REQUEST FOR QUOTATION
EDUCATION CENTRE – WASHROOM UPGRADES
TZC T 03-2021-08
ADDENDUM #1

Project Name:	Education Centre Washroom Reno	Addendum #:	AD-01
Project Number:	1193059	Date:	August 21, 2021
Project Address:	200 Meadowvale Road Toronto, Ontario	Client:	Toronto Zoo

Subject: Partition Revision

5 SECT - NEW PARTITION
 1 : 10

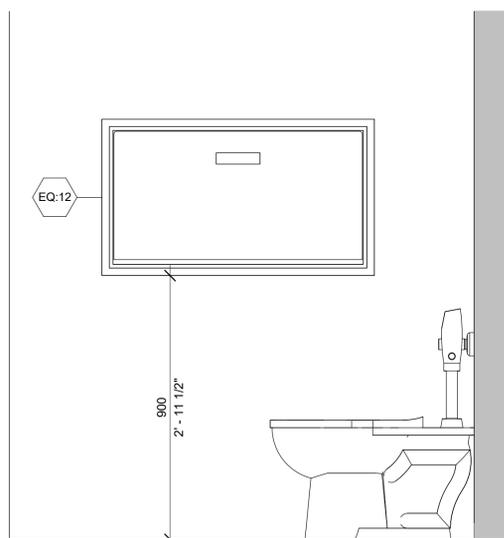
1. Contractor to refer to attached drawing for revision to the partition required to extend the washroom. The partition shall be angled and fasten to the existing concrete wall rather than fasten to the steel deck above
